ADDENDUM #2

Coastal Carolina Community College
Learning Resources Center
First Floor Renovation
SCO ID: 23-26060-01A

This addendum forms a part of the contract documents and modifies the original drawings and project manual dated November 2024. The enclosed additions, deletions, corrections, and changes shall be as binding as if incorporated in the original documents. All General Conditions, Special Conditions, etc. as originally specified shall apply to these items. Acknowledgement of receipt of this addendum will be required as part of the contract agreement.

G1.2

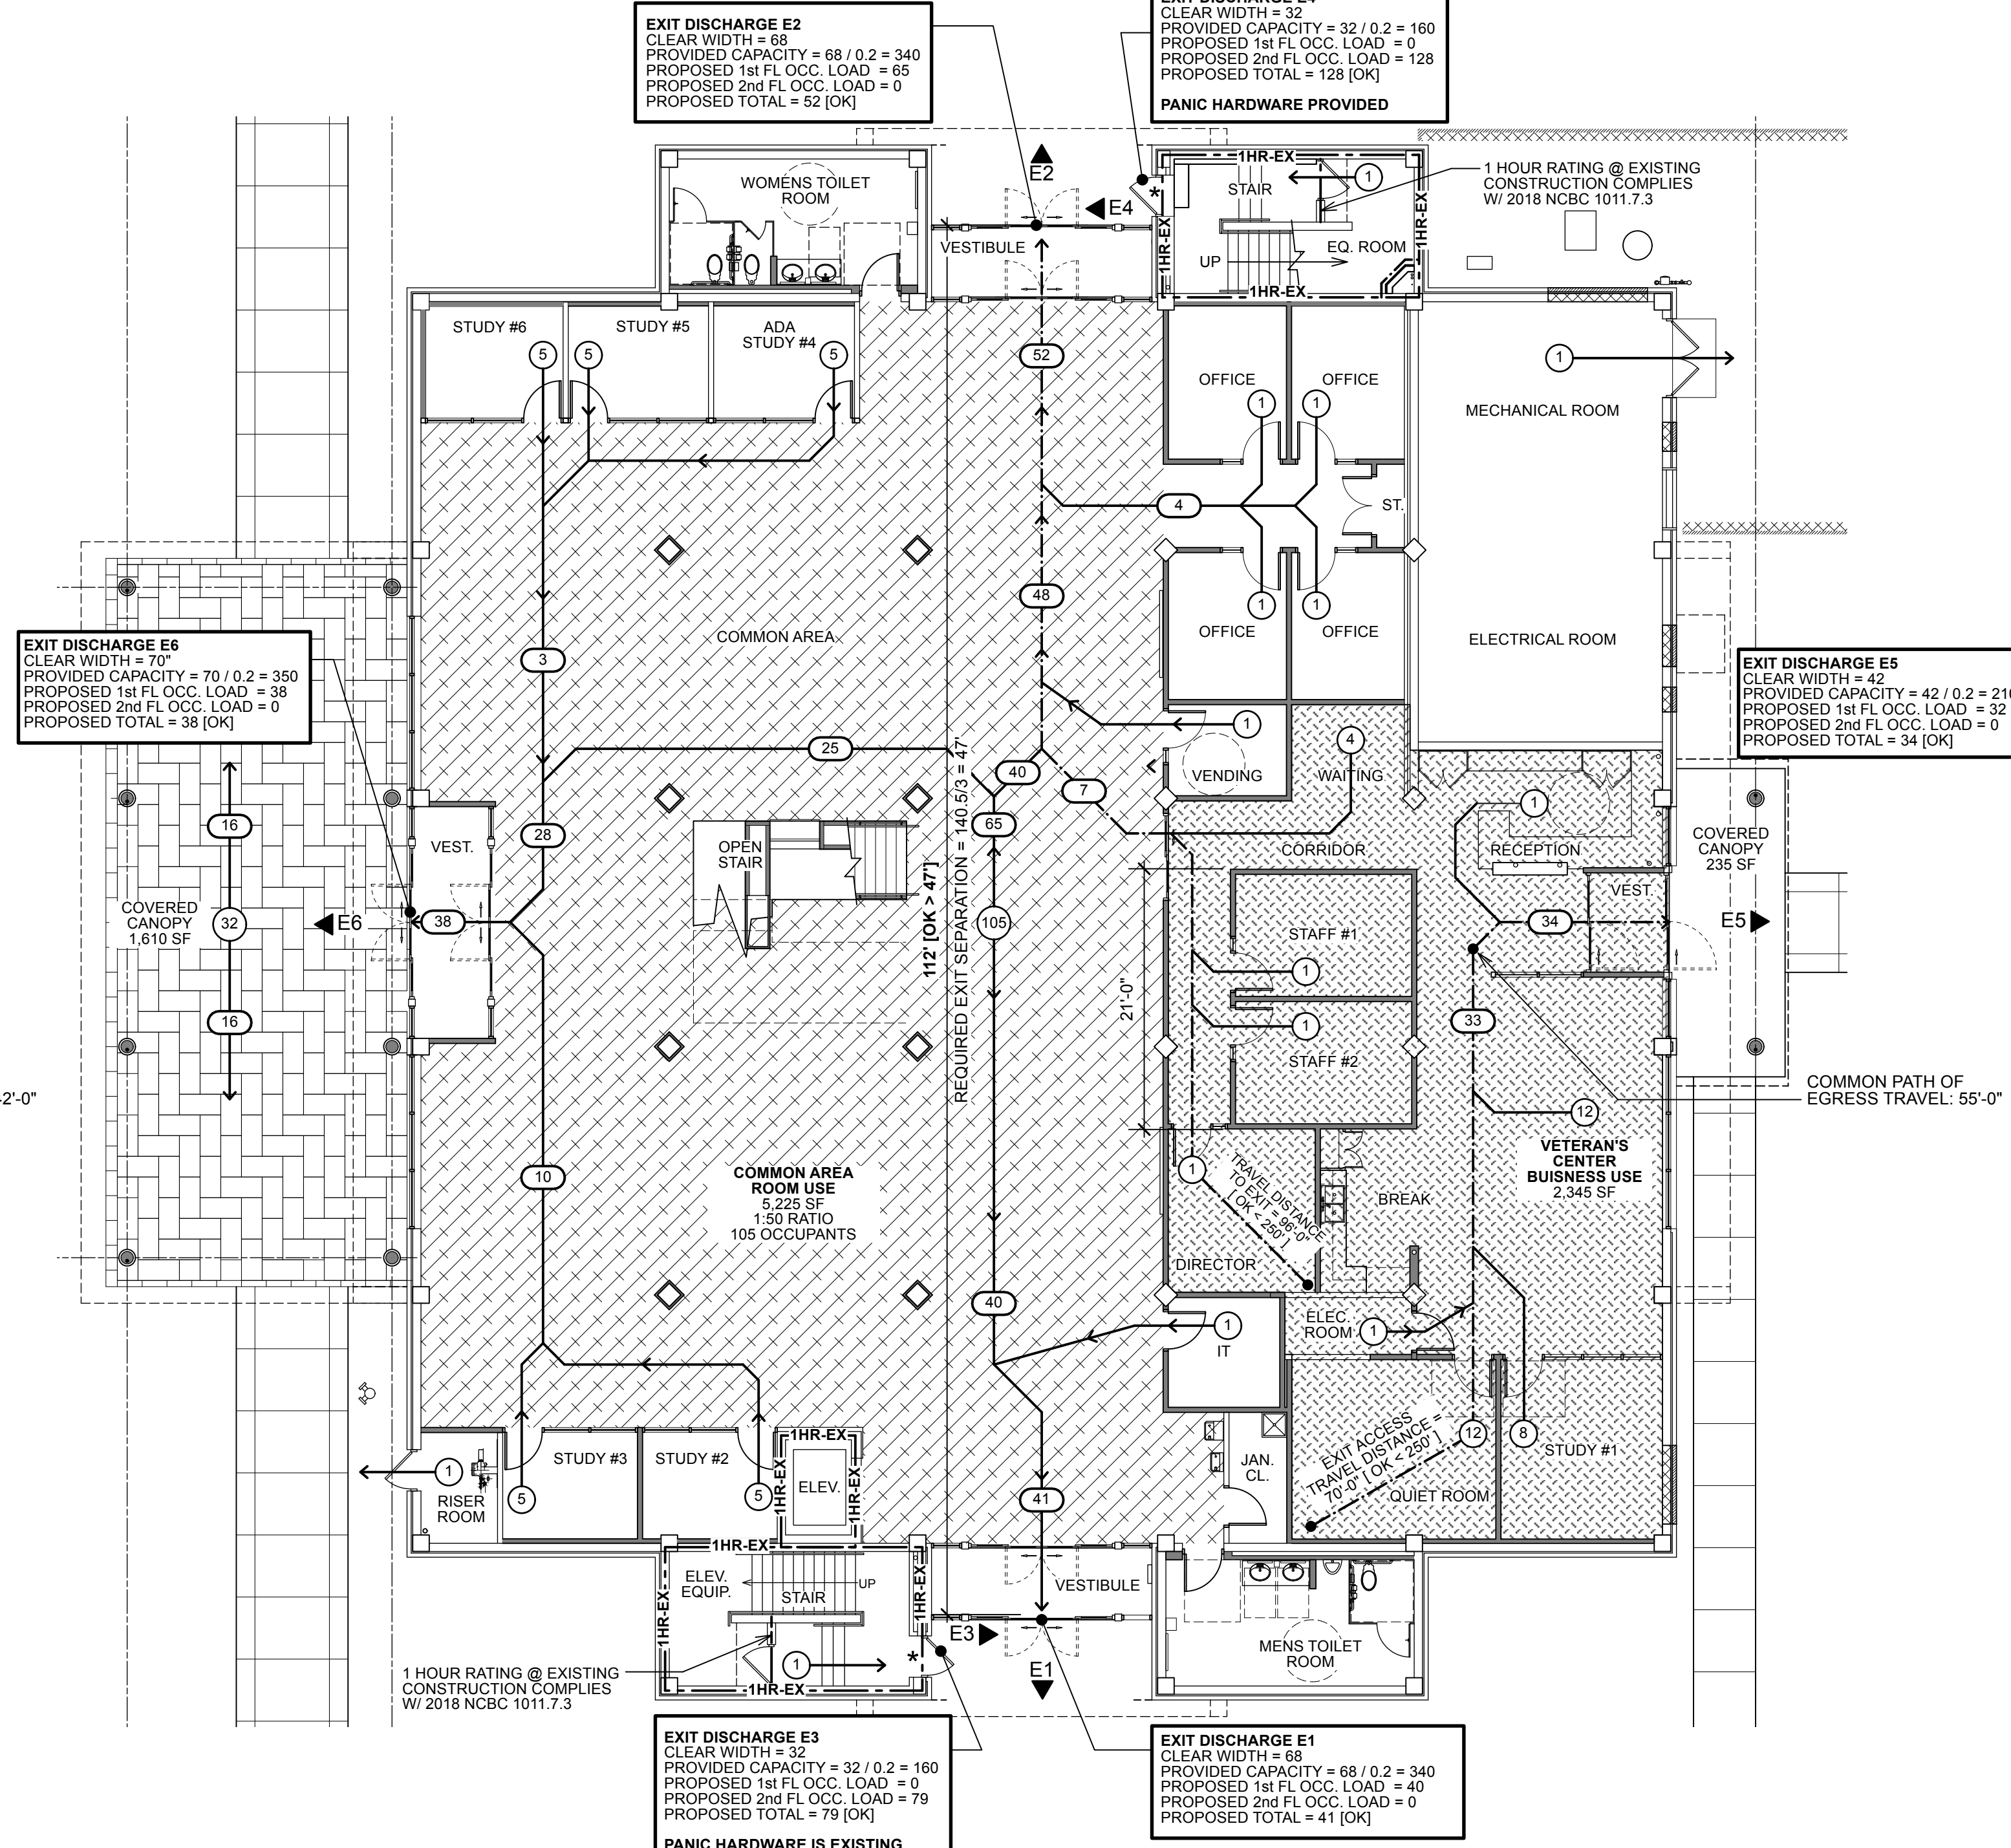
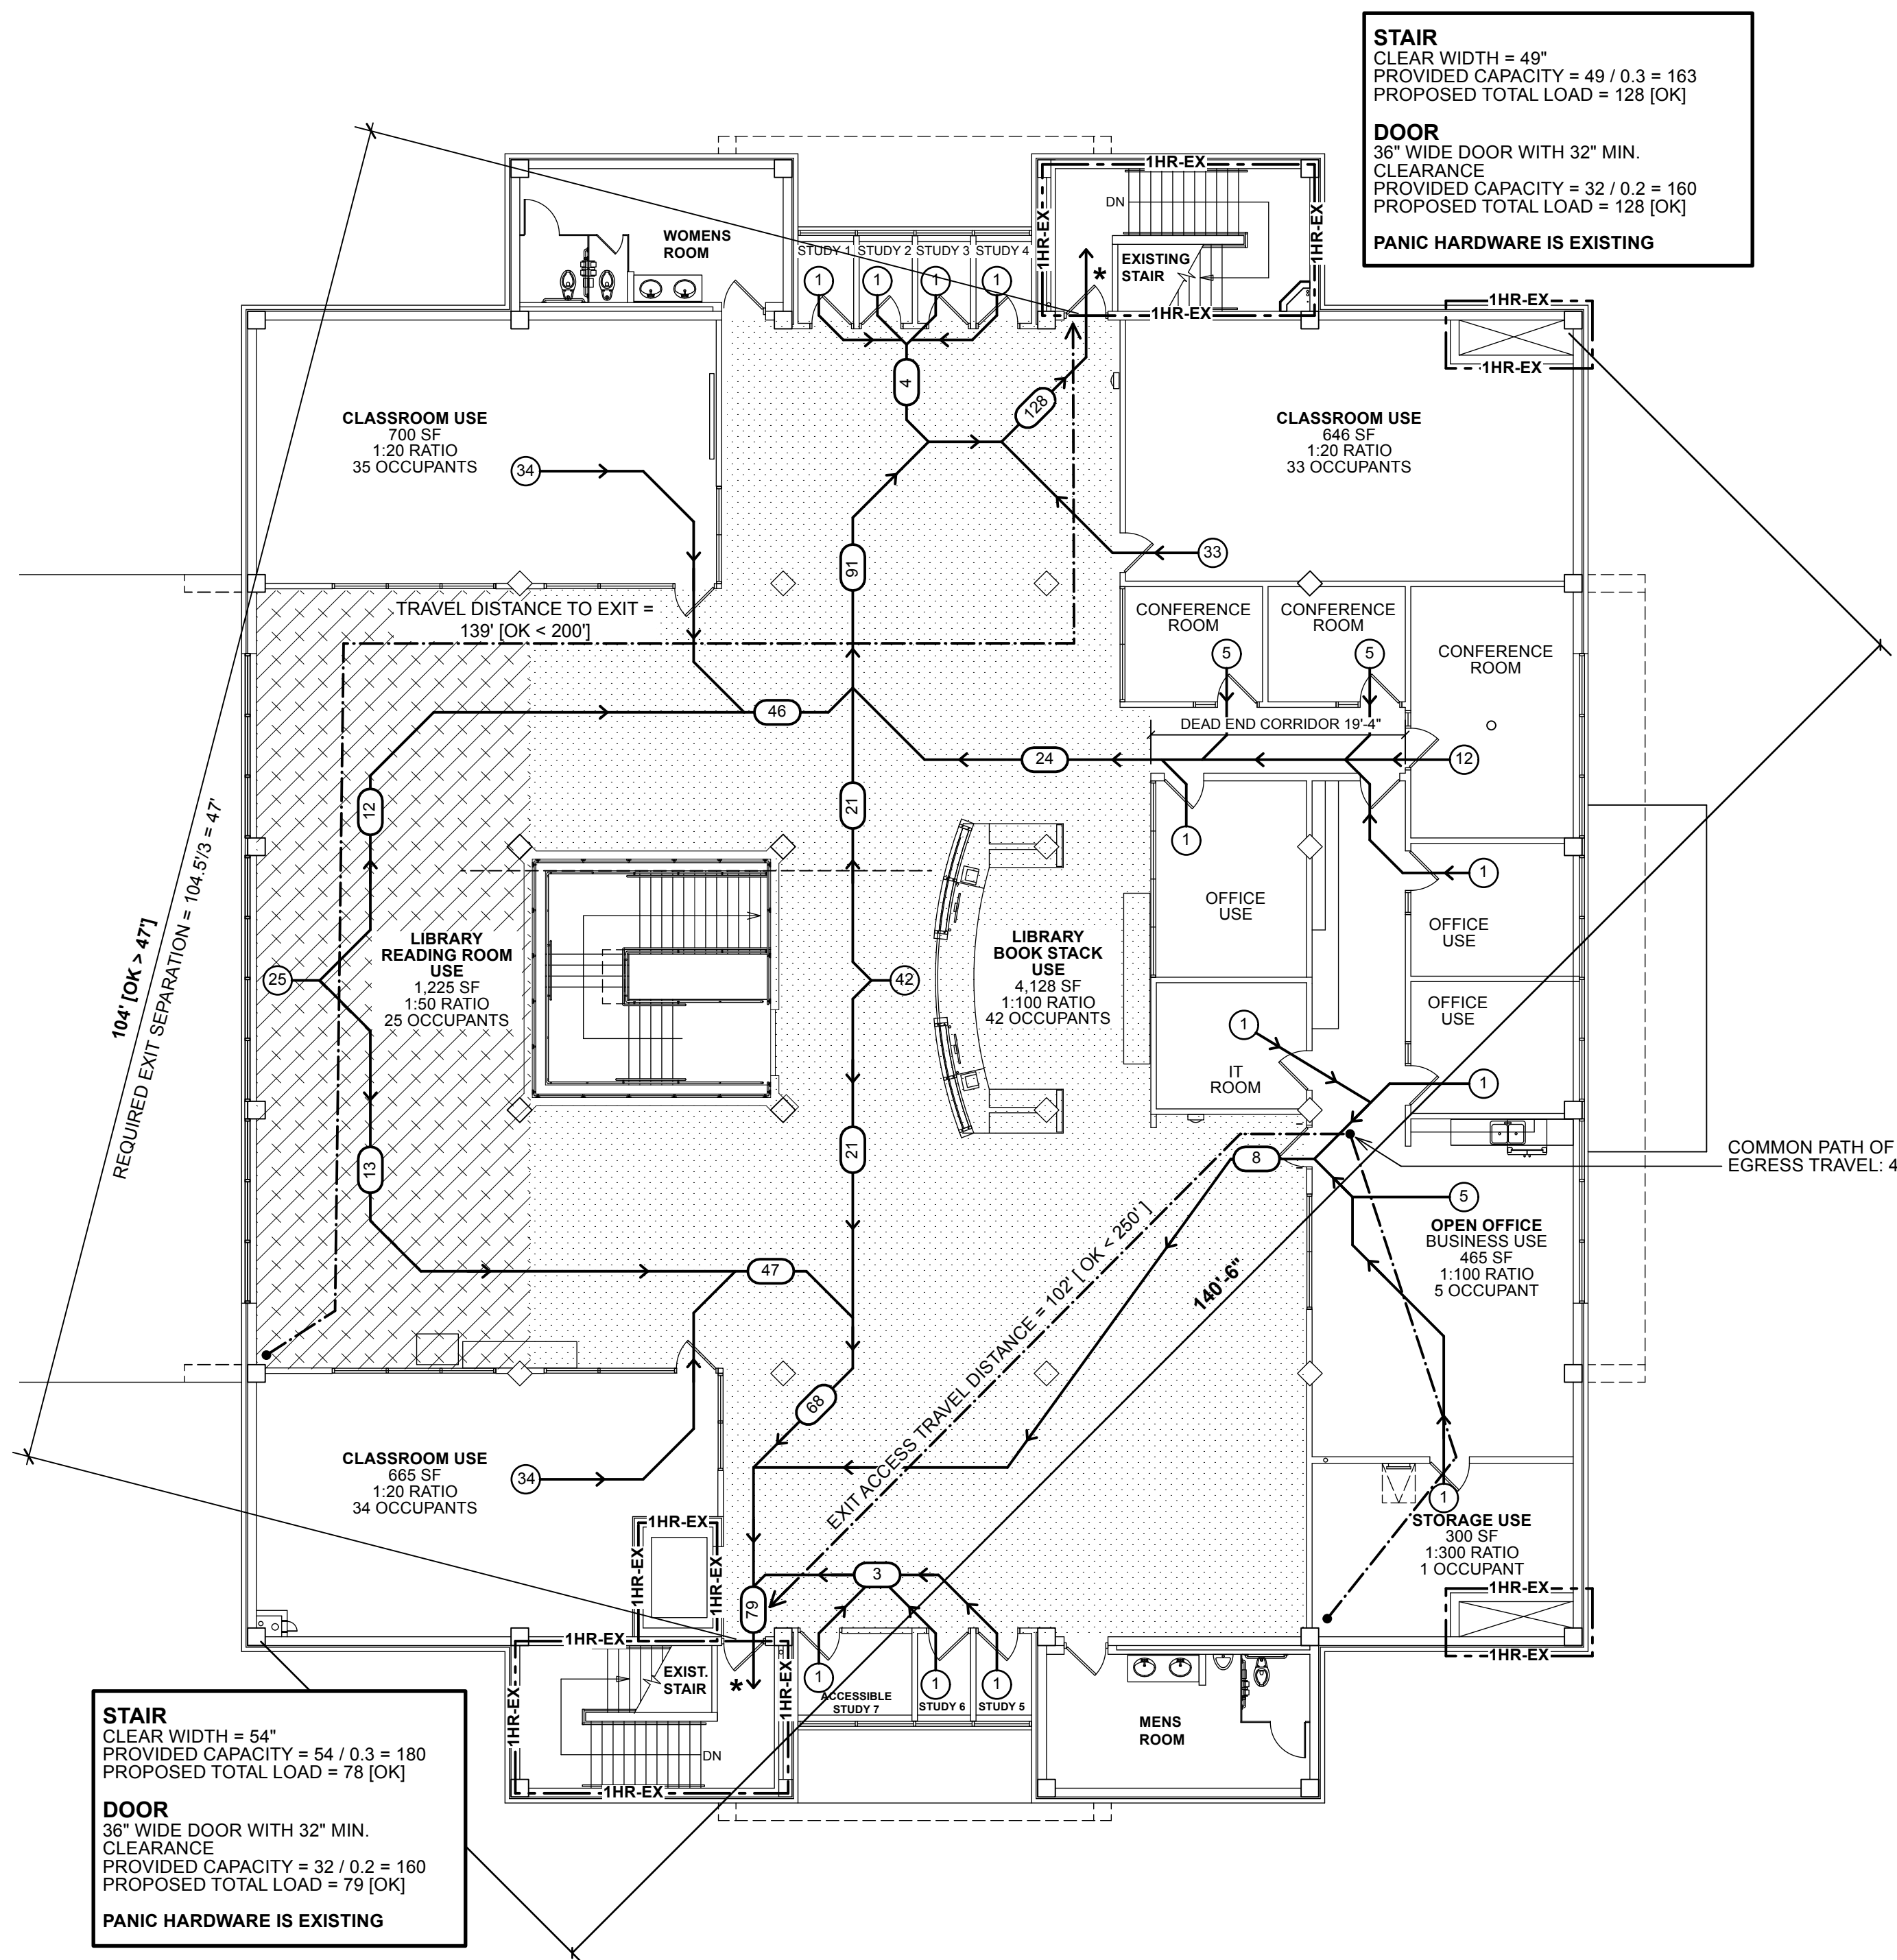
Item 8 Architectural Drawing Sheets G1.1 and G1.2

There was a minor mathematical error recorded on sheet G1.2 for the total first floor occupant count. Architectural drawings G1.1 and G1.2 have been revised and submitted to the City of Jacksonville. Revised drawings are included as **Attachment #3 and #4.**

FIRST FLOOR: 12,995 SF TOTAL
TOTAL OCCUPANTS FOR FIRST FLOOR: 163 (A-3) + 38 (B) = 201 TOTAL
201 TOTAL = 100 FEMALE & 100 MALE
SECOND FLOOR: 10,445 SF TOTAL
TOTAL OCC. FOR SECOND FLOOR: 199 (A-3) + 8 (B) = 207 TOTAL
207 = TOTAL 104 FEMALE & 104 MALE
TOTAL: 408
MEN: 204
WOMEN: 204

Project Manager	Drawn By
11-25-2024	Reviewed By
Project ID	
Sheet Title	
ELECTRICAL SCHEDULES AND DETAILS	
Sheet No.

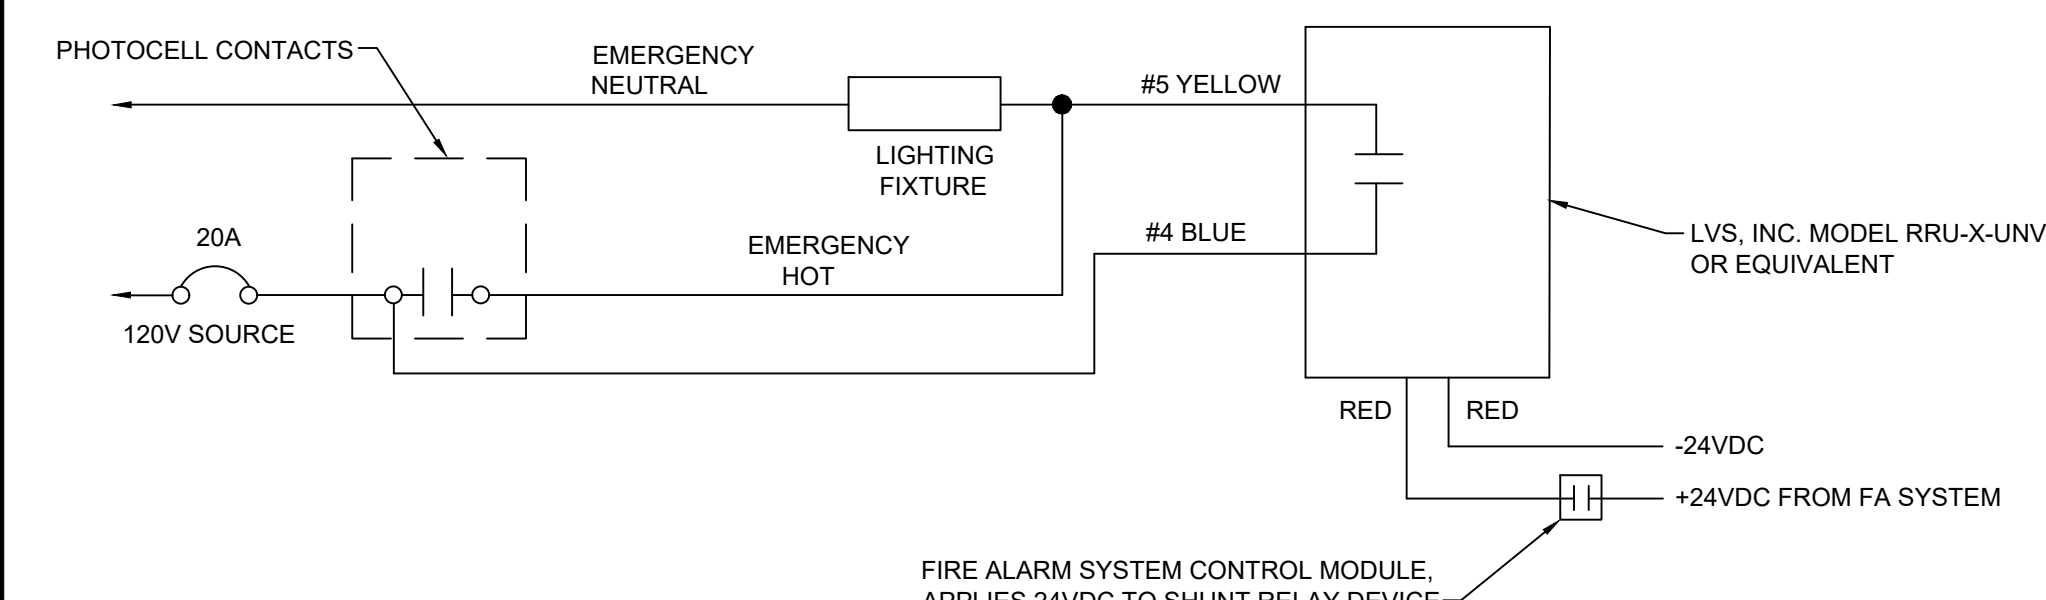
Item 10 Electrical Drawing E-0.9

The specified exterior lighting fixture types L12 and L12E have a B.U.G. rating of U=0. The Lighting Fixture Schedule has been revised to indicate this requirement. Revised drawing sheet E-0.9 is included as **Attachment #6.**

REMARKS:
 1. BI-LEVEL SWITCHING
 2. DAMP LOCATION
 3. WET LOCATION
 4. WIREGUARD
 5. LED REQUIRED SURGE PROTECTION
 6. FINAL COLOR SELECTION BY ARCHITECT
 7. AR TRIM, TRW TRIM, MWD DIST.
 8. NOT USED
 9. NOT USED
 10. TILT/ABLE STAND
 11. 0-10V NON-DIMMING DRIVER, RATING AS REQUIRED BY LOAD
 12. 0-10V DIMMING DRIVER(S), RATING AS REQUIRED BY LOAD
 13. END FEED BARE WIRE CONNECTION
 14. FACTORY ASSEMBLED
 15. FIELD ASSEMBLED
 16. PROVIDE 90 MINUTE BATTERY BACKUP FOR 100% FIXTURE OUTPUT
 17. LIGHTING FIXTURE MUST BE PROVIDED WITH B.U.G RATING OF U=0.
